Northern States Power Company  
 Prairie Island Nuclear Generating Plant  
 1717 Wakonade Dr. East  
 Welch, Minnesota 55089

PRAIRIE ISLAND NUCLEAR GENERATING PLANT  
 Docket Nos. 50-282 License Nos. DPR-42  
 50-306 DPR-60

Response to the August 30, 1995 Request for Additional  
 Information Regarding Generic Letter 92-08, "Thermo-Lag 330-1 Fire Barriers"  
 (TAC Nos. M85592 and M85593)

## ASTM E119.88 STANDARD CURVE FTC FURNACE TEMPERATURE

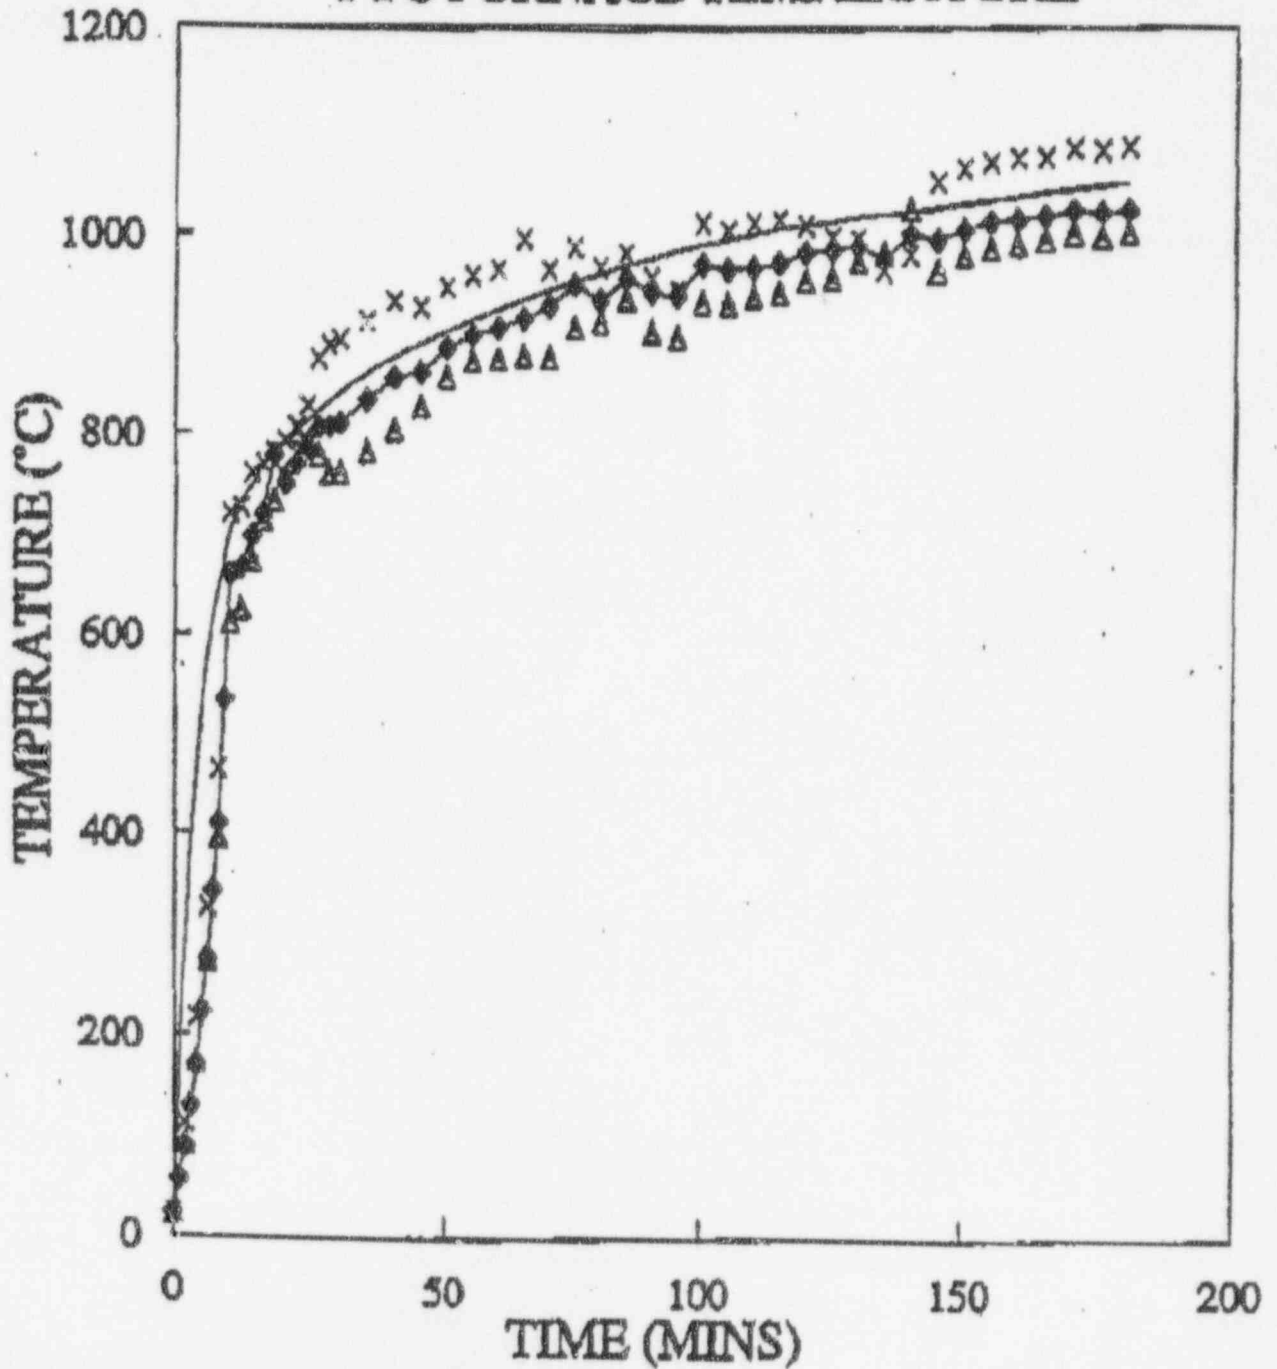
**Section 4.2 of the test report states that ASTM [American Society for Testing and Materials] thermocouples provided by Underwriters Laboratories were used for reference, and positioned next to the controlling thermocouples. Please provide the thermocouple temperature data, and a comparison of the temperature data recorded by both the ASTM thermocouples and the controlling thermocouples related to the ASTM E-119 standard time temperature curve.**

The temperatures recorded by the British Standard controlling thermocouples were so close to the ASTM E119-88 Standard curve that only a single line is shown. The temperature data is shown on Page 25 of the report
